Drawing title: Proposed Elevations		
Contract No. :	099/91758 B Page 4 of 5	
Proposed At:	PVCu WHITE KNIGHT CONSERVATORY 53 NORTH SHORE ROAD HAYLING ISLAND HAMPSHIRE PO11 0HN	
For :	DR GREENWOOD	
Drawers initials:	Lsh	Scale : 1:50
Date:	15.09.2016

Regency shaped frame sizes
Scale: 1-20

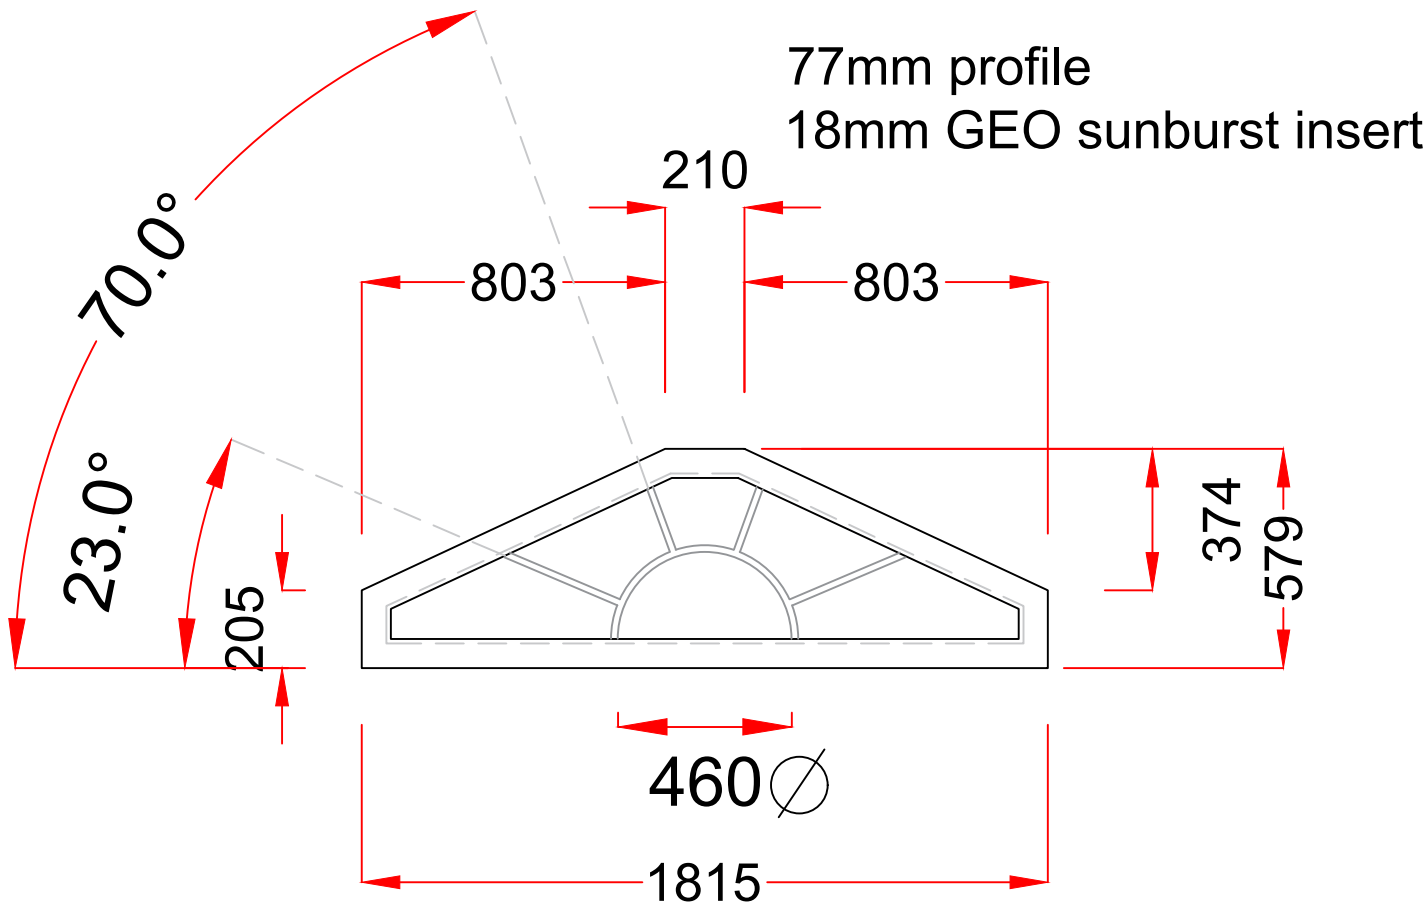
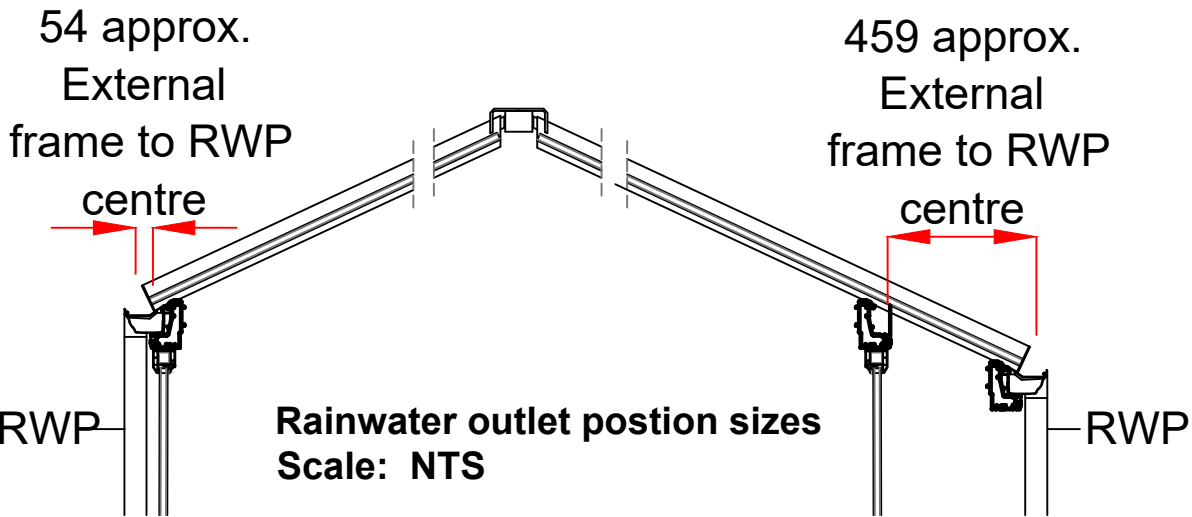
PLEASE NOTE! 18mm arched inserts NOT lining through at same level due to minimum arch on small frame adjacent to single door being at minimum 200mm radius which results in a 73mm arch drop not being enough to get below door leaf sightline. Left hand fixed side frame also done to a 73mm drop (arch radius is 1032mm) Double door arch drop 73mm (arch radius is 750mm).

Revisions (Starting from bottom)			
B	13/01/17	Customer supplied information correction and addition order info added for arched insert, RWP positions.	SDr
A	15/12/16	Sunburst amended to 18mm lead @ 460Ø circle bars with 23° and 70° bars with safe and sound glass. 18mm arched inserts added (NOT lining through due to minimum arch on small frame adjacent to single door). Physical barrier night vents removed and breaks amended to minimum parameters. Obscure glass amended to Cotswold.	SDr
